SMART Brief

T E C H N I C A L B U L L E T I N

DATE: Wednesday, January 09, 2008 **No:** SB-010908
TO: Contractors & Distributors **Page** 1 of 1
FROM: Metro Technical Services Division
SUBJECT: **Profiled Roman Bird-Stop Installer Correction Steps**

Profiled Roman Bird-Stop Installer Correction Steps

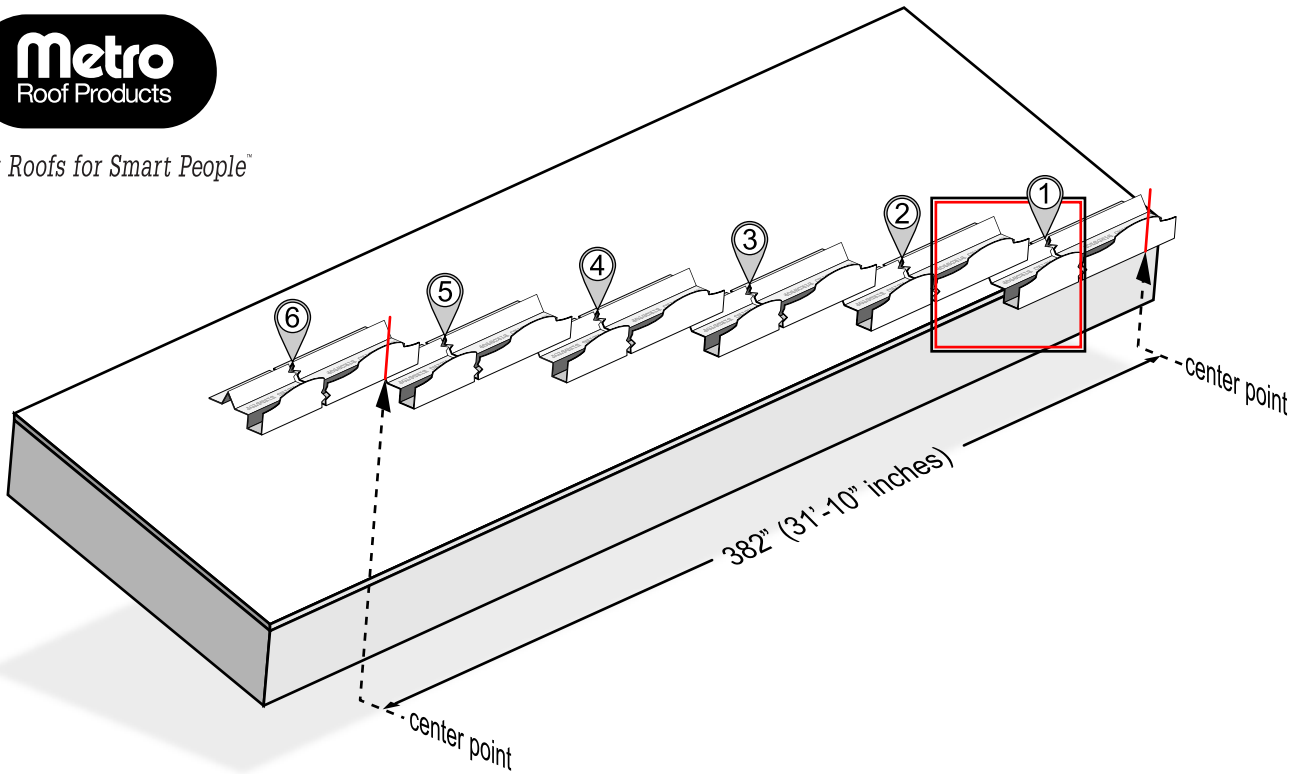
Verify which type of Roman Bird-Stop you have? 'Old' Roman Bird-Stop is stamped with the words "METRO BIRDSTOP". 'New' Roman Bird-Stop has no stamped name markings.

The 'Old' Roman Bird-Stop measures 76-5/8" long and is installed by 'Lapping' each piece a 7/16" providing an exposure of 76-3/16.

For long Fascia lengths, as a spot-check, the measurement from the center of the 1st Bird-Stop Over-Pan (Hump) section to the center of the 1st Over-Pan on the sixth (6th) Bird-Stop piece measures **382-inches (31'-10").**

Metro Roman panels must be center-aligned over a corresponding Over-Pan (Hump) section of the Metro Roman V-Bat Bird-Stop below.

The 'New' Roman Bird-Stop (No markings) can be installed by butting each piece across the fascia.

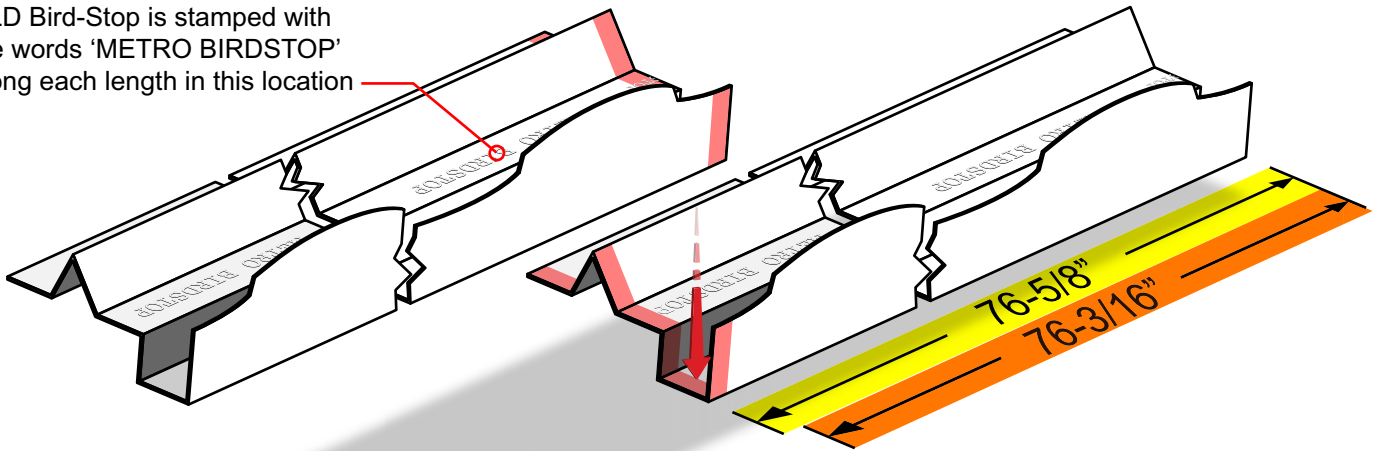
OLD Bird-Stop is stamped with the words 'METRO BIRDSTOP' along each length in this location

"Old" Bird-stop Measurements	
	Overall Length
	Exposure Length
	Lap Length
